ADDENDUM NO. 2

Reference: New Tooele Applied Technology College
Utah College of Applied Technology – Tooele, Utah
DFCM Project No. 11064280

ADDENDUM NO. 2
February 10th, 2012

Tooele Applied Technology College New Building
Tooele, Utah

sheet:
AE603

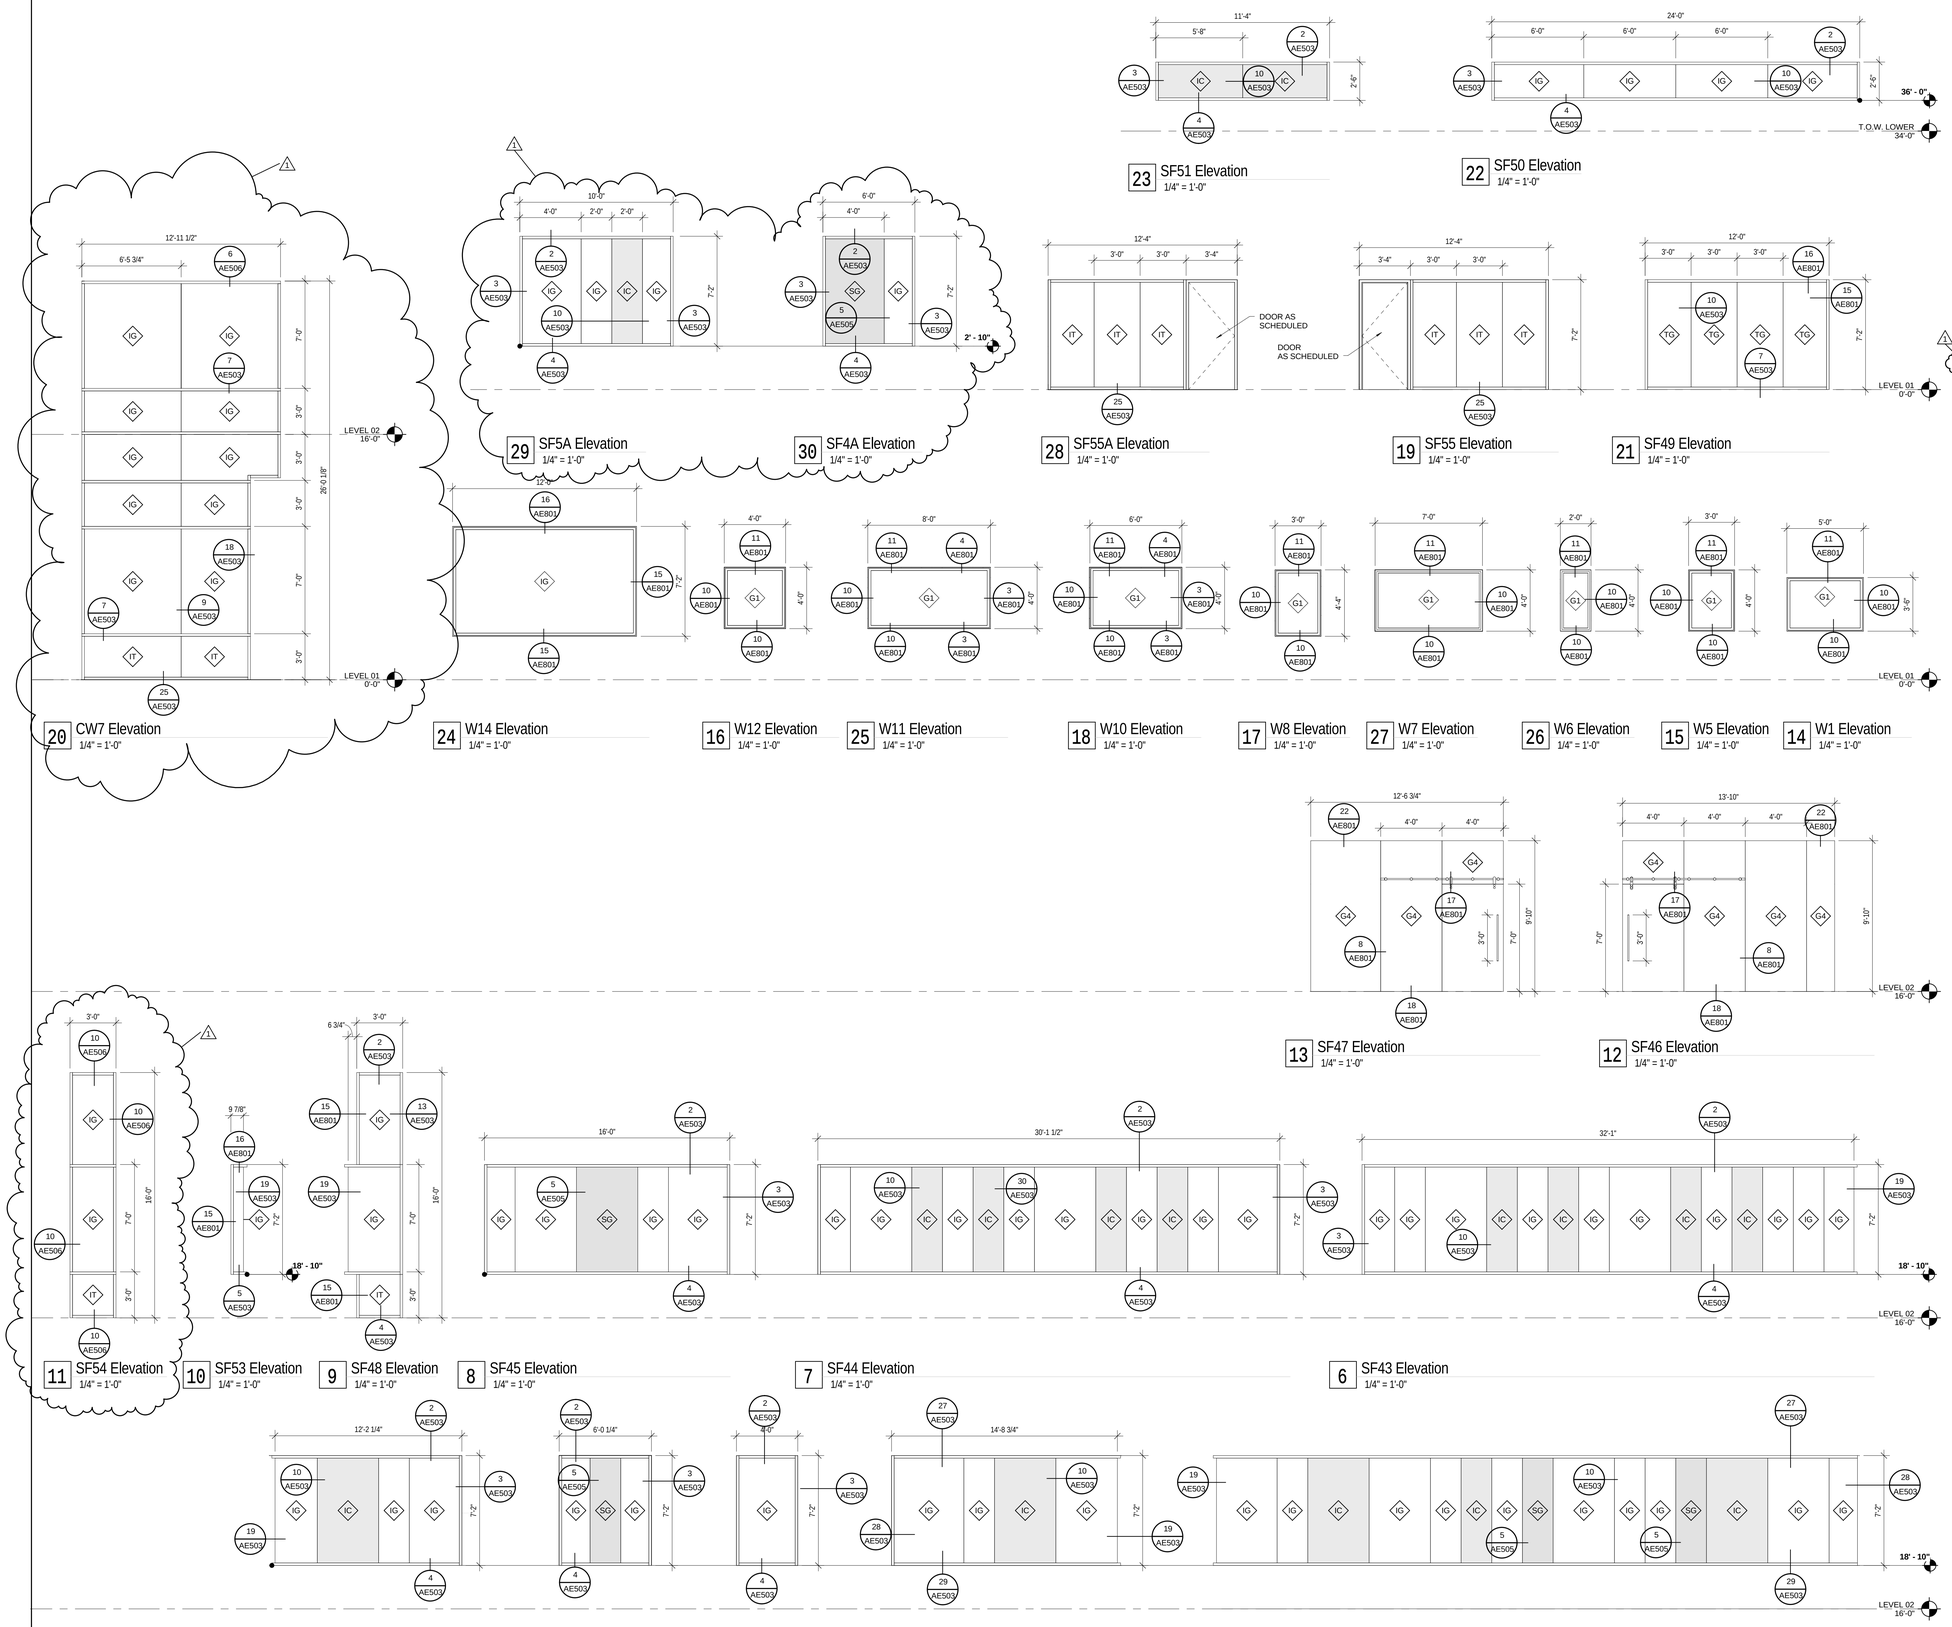
AD2-A32 Sheet AE603 Elevations 3,4,8,29,30
Window dimension, components and detail reference clarifications. See attached sheet.

sheet:
AE911

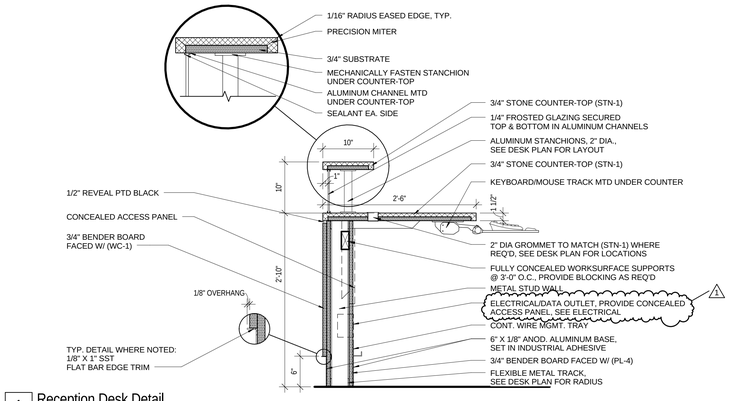
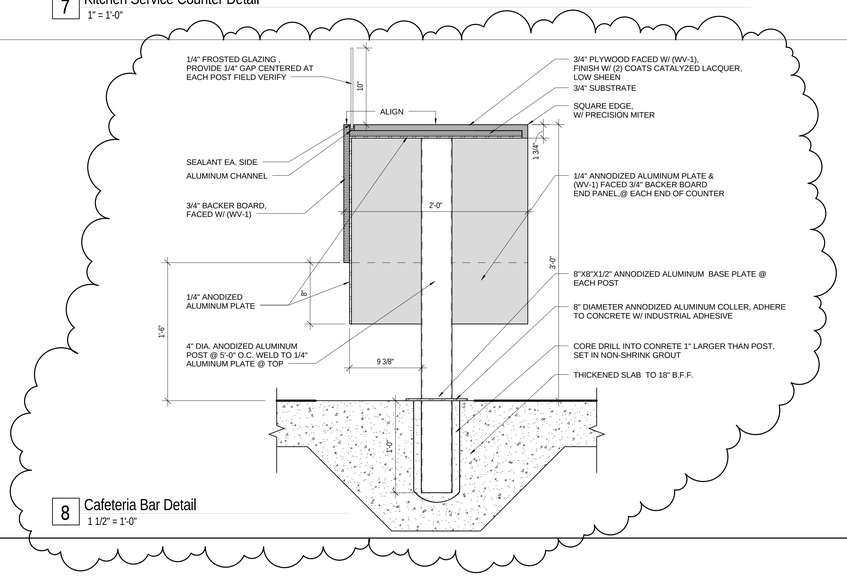
AD2-A38 Sheet AE911 Details 1,7,8
Clarifications to casework finishes, materials, spacing and anchorage. See attached sheet.

A1 SF101 SECOND FLOOR FRAMING PARTIAL PLAN 1

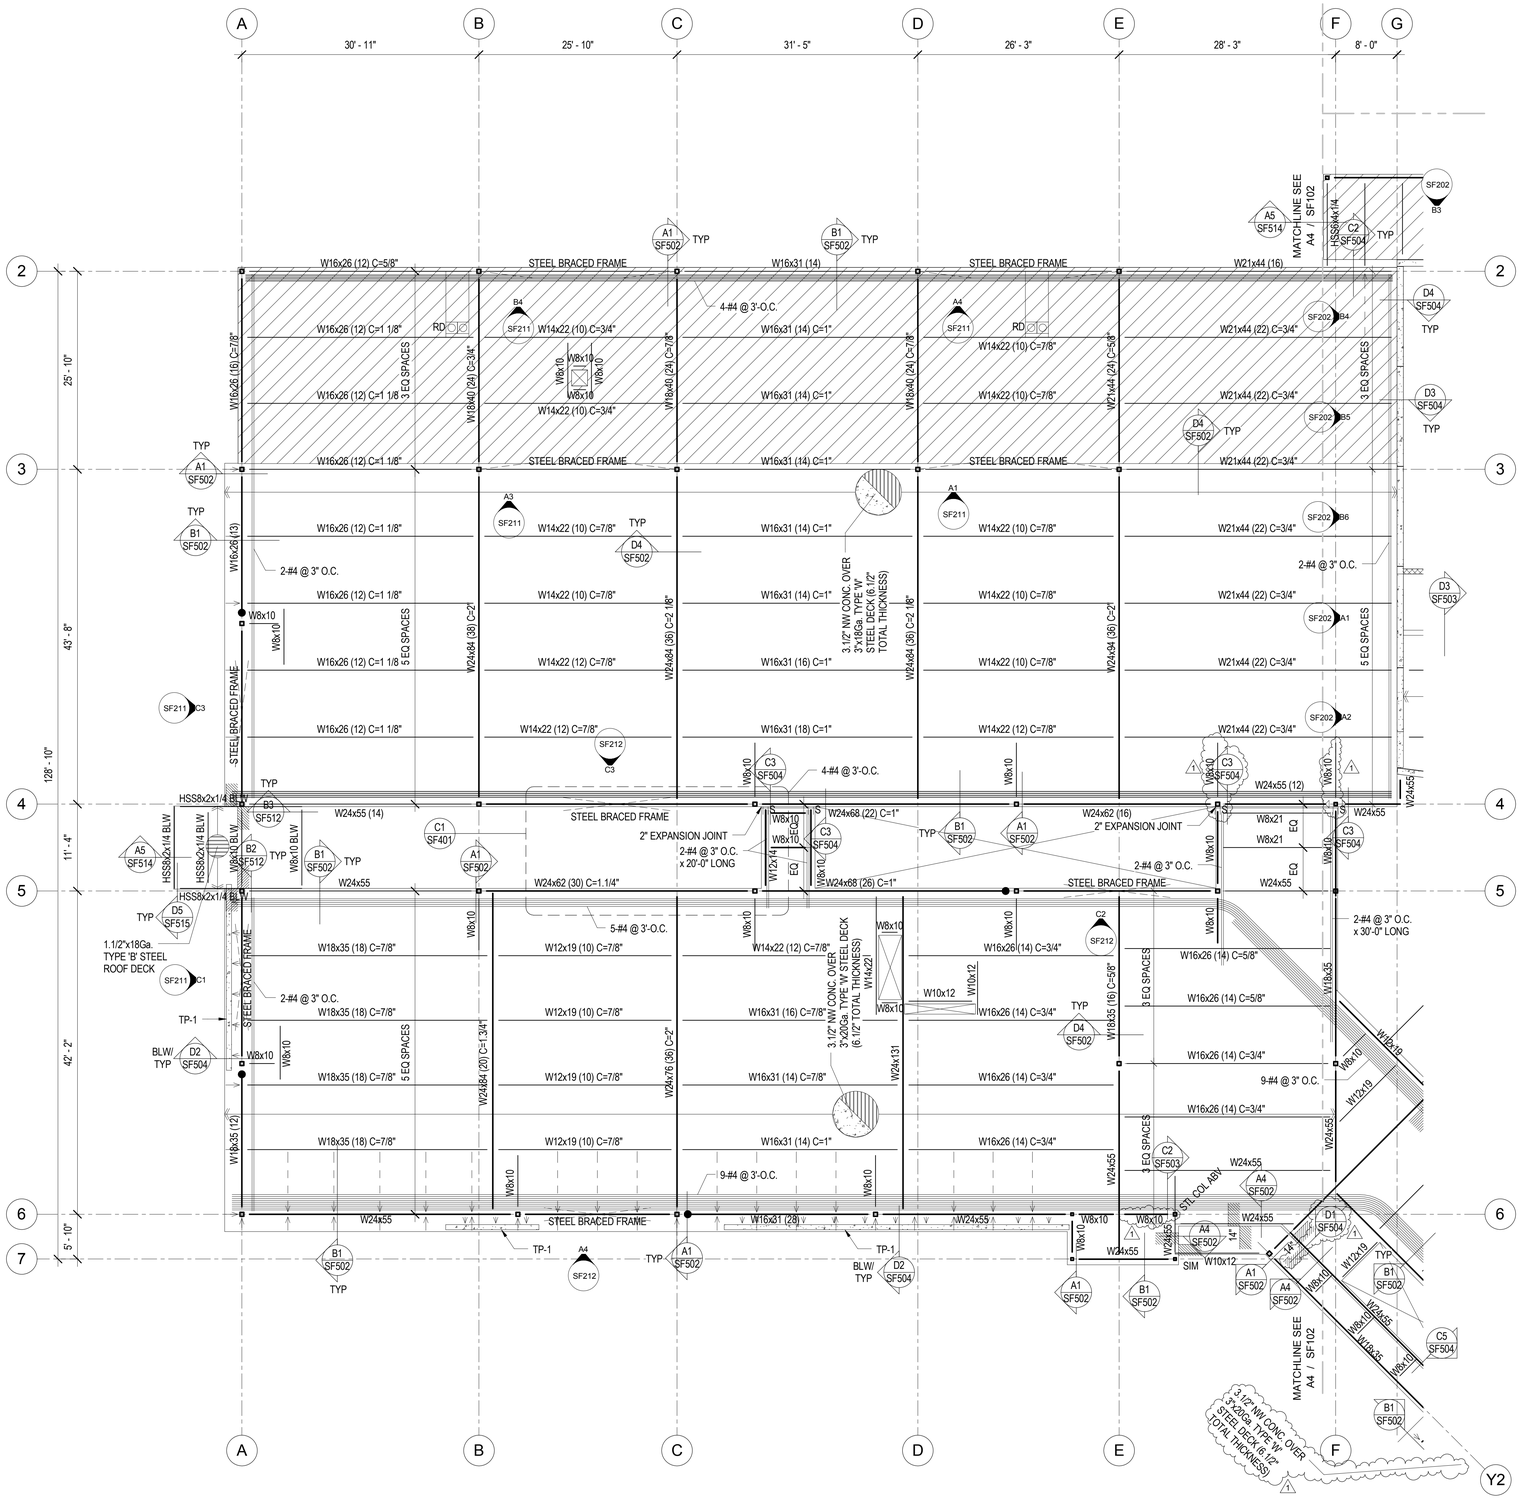
AD1-S03 Sheet SF101
Added beams at clouded locations.See attached sheet.

A4 / SF102 SECOND FLOOR FRAMING PARTIAL PLAN 2

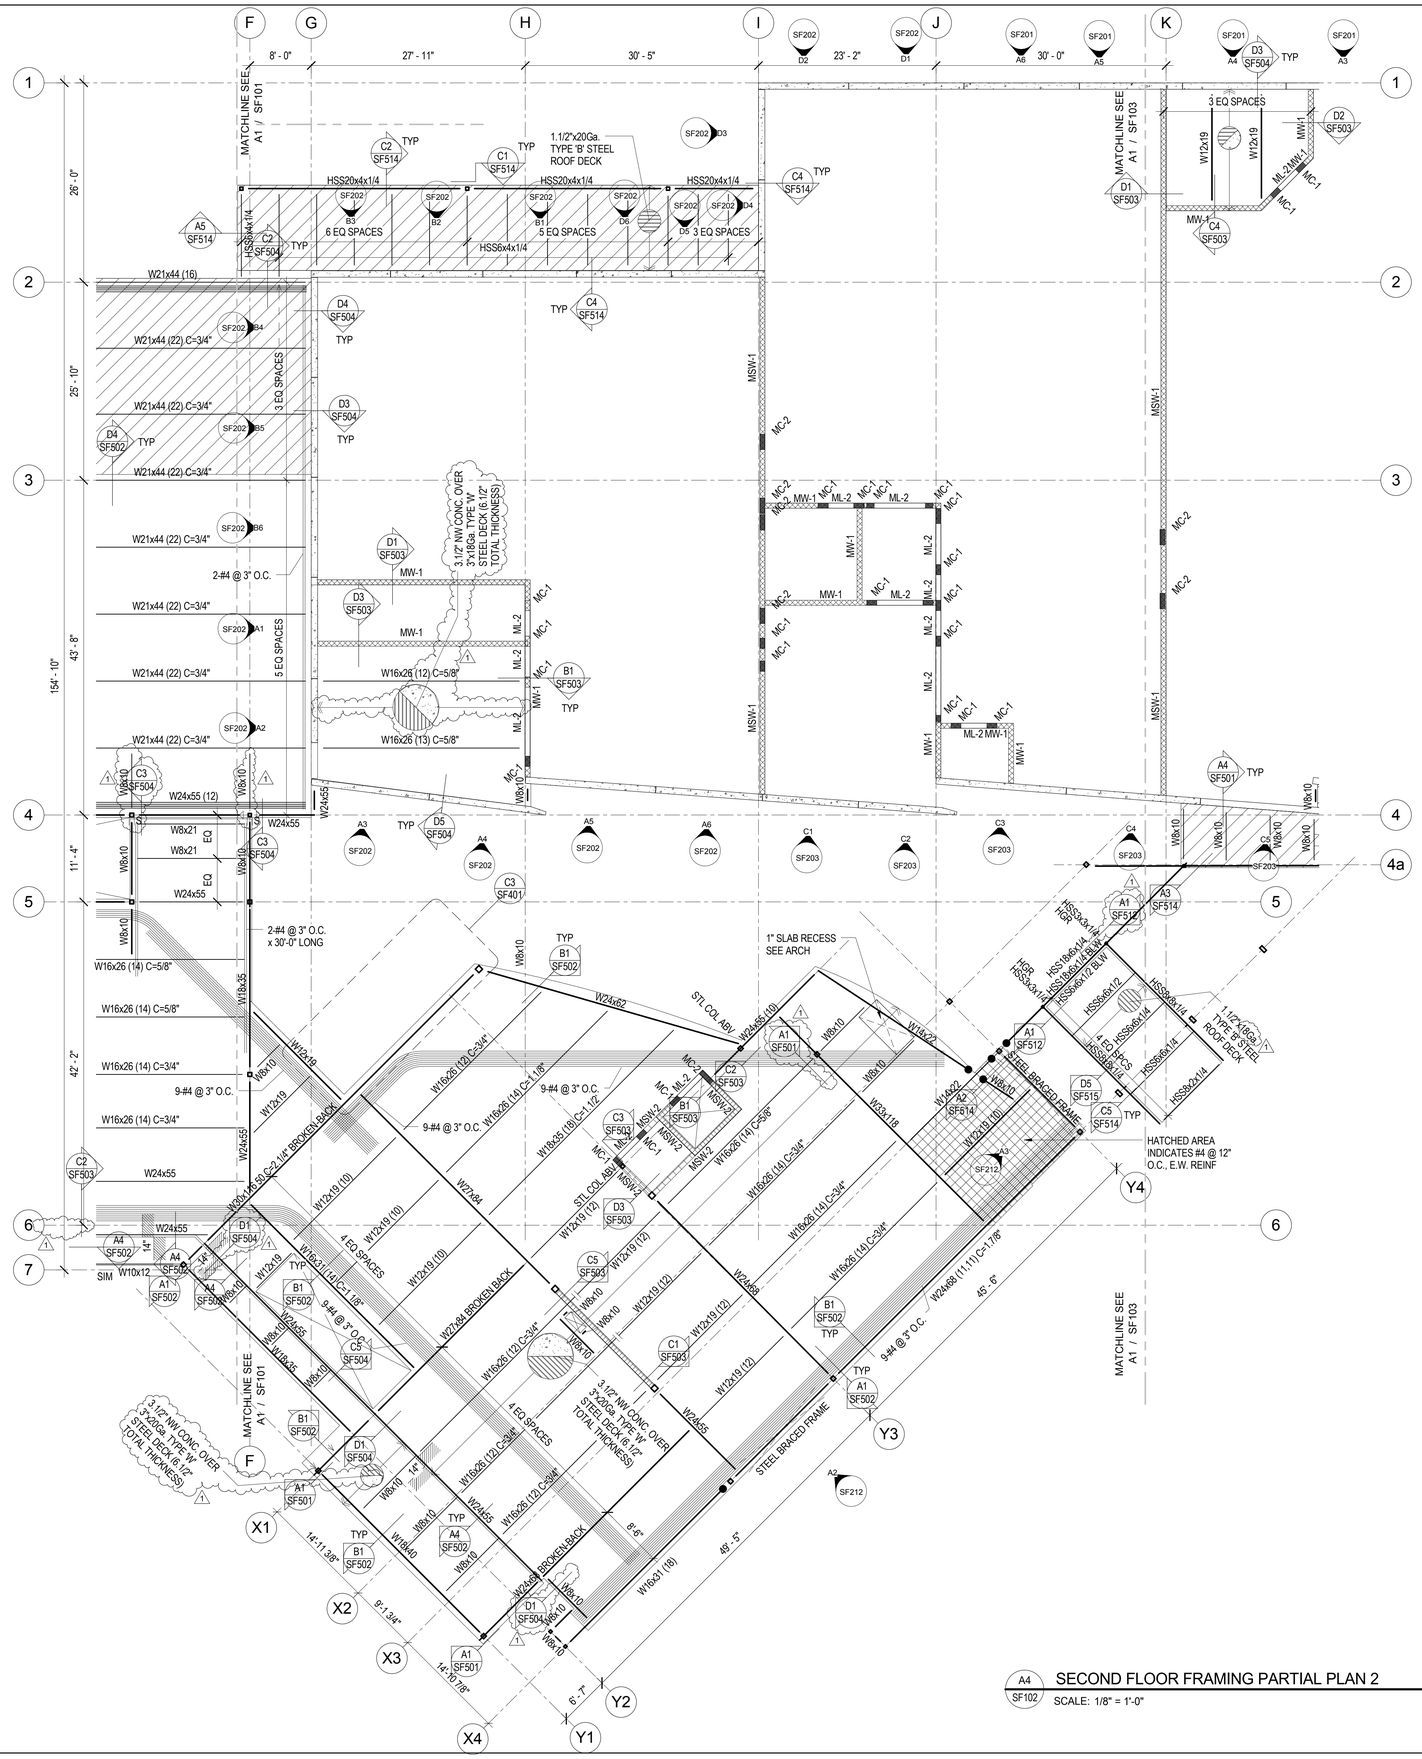
AD1-S04 Sheet SF102 See attached sheet.
1. Added detail callouts.
2.Modified entry canopy steel deck.
3. Clarified deck callouts.

A1 / SF123 UPPER ROOF FRAMING PARTIAL PLAN 3

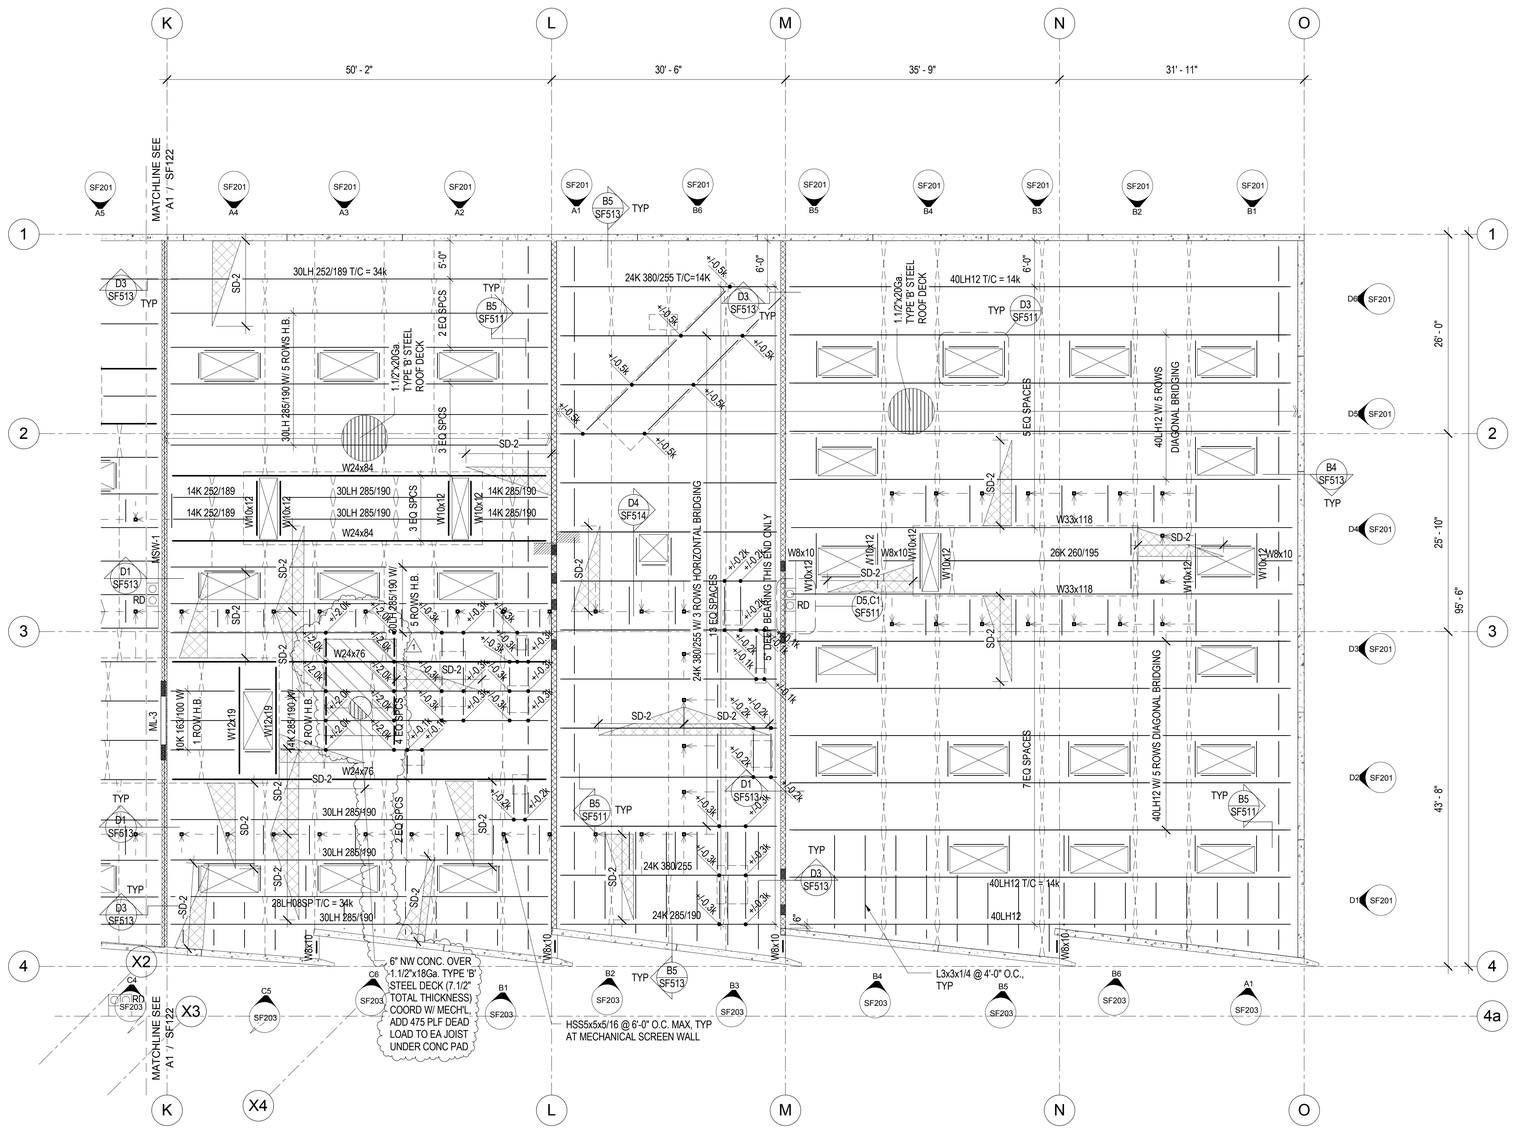
AD1-S06 Sheet SF123
Added concrete house keeping pad at clouded area. See attached sheet.

sheet:
ME604

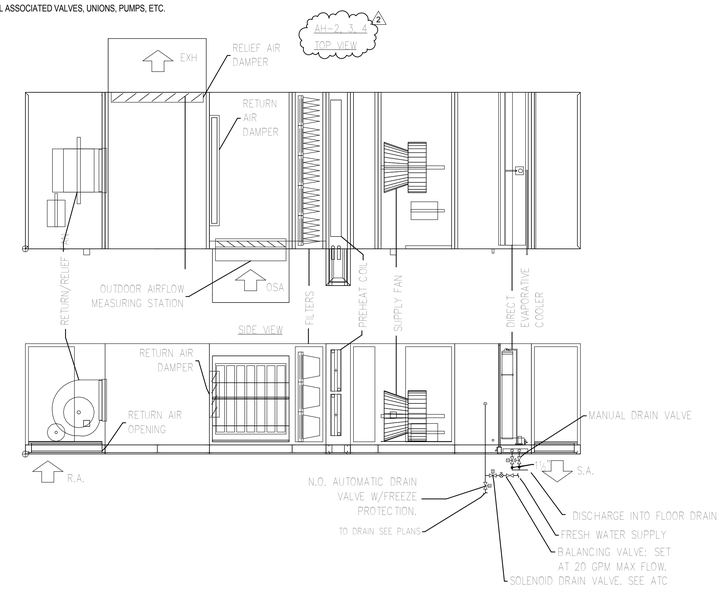
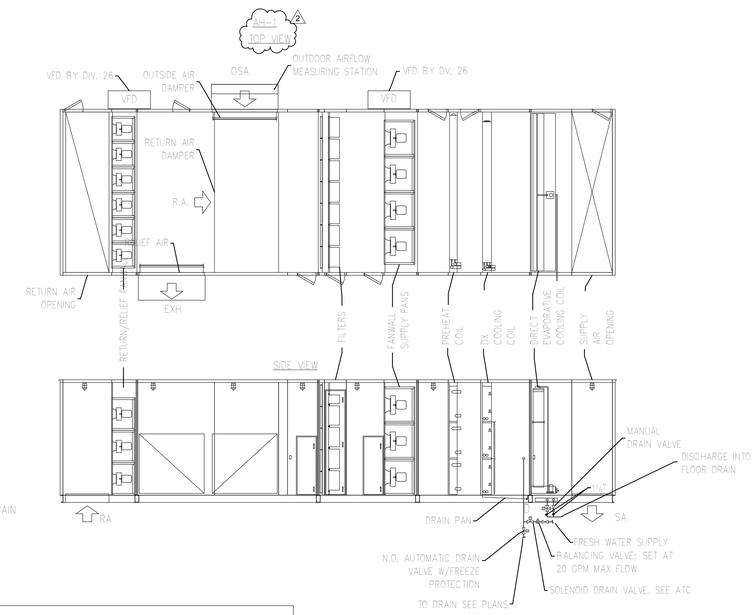
AD2-M10 SHEET - ME604
1. Revise performance requirements of split AC unit AC-5/CU-5. See attached.
